Product Change Notification

Change Notification #: 115572 - 00

PCN 115572-00, Product Design,

Manufacturing Process Change to Remove Unused Test Header

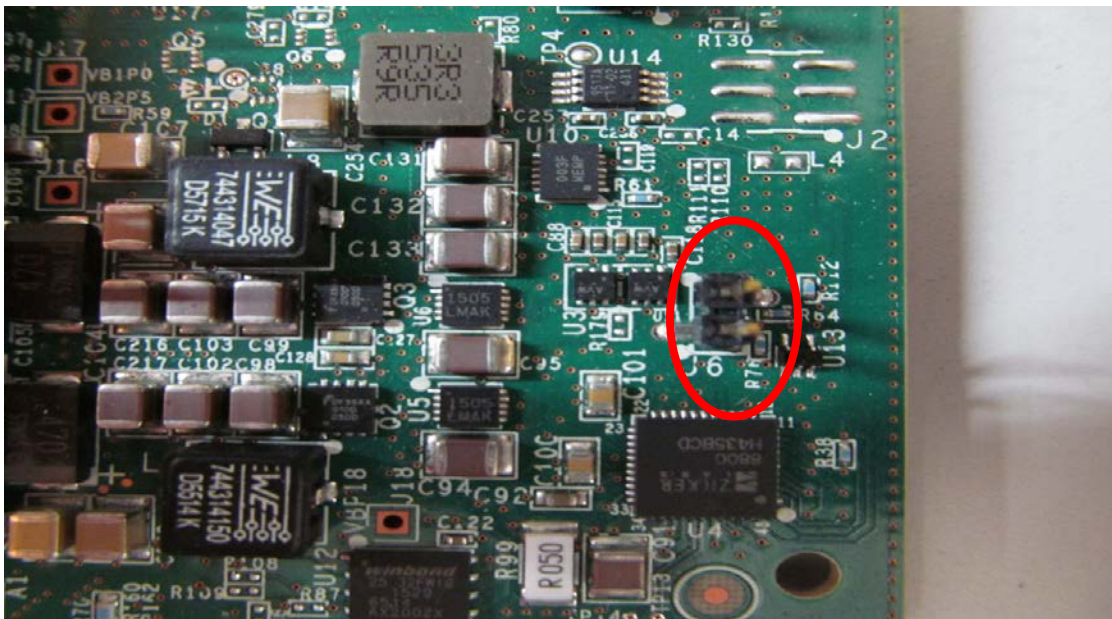
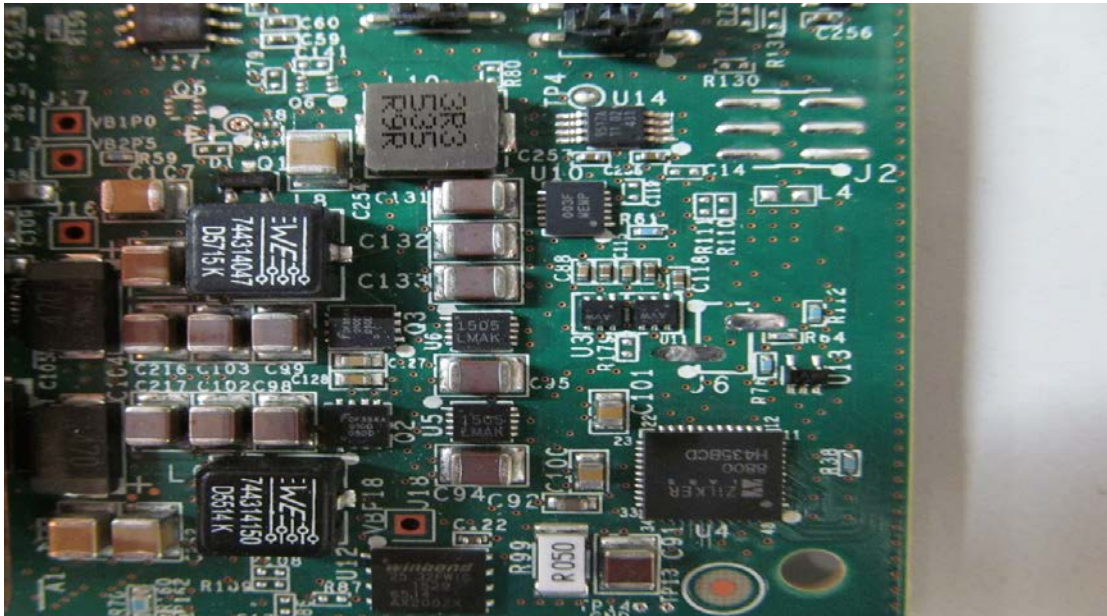
The J6 header will be removed from the right side of the HFI adapters as a manufacturing process improvement. This component is located on the topside of the adapter at the far end - away from the bracket - per the pictures below. This change is benign to product fit and function since this manufacturing header is no longer used. This header is not used by the customer. The planned change to manufacturing process has been evaluated to ensure no quality, reliability or functional impacts to our customers.

This change does not impact fit or function of the adapter and no customer action is required.
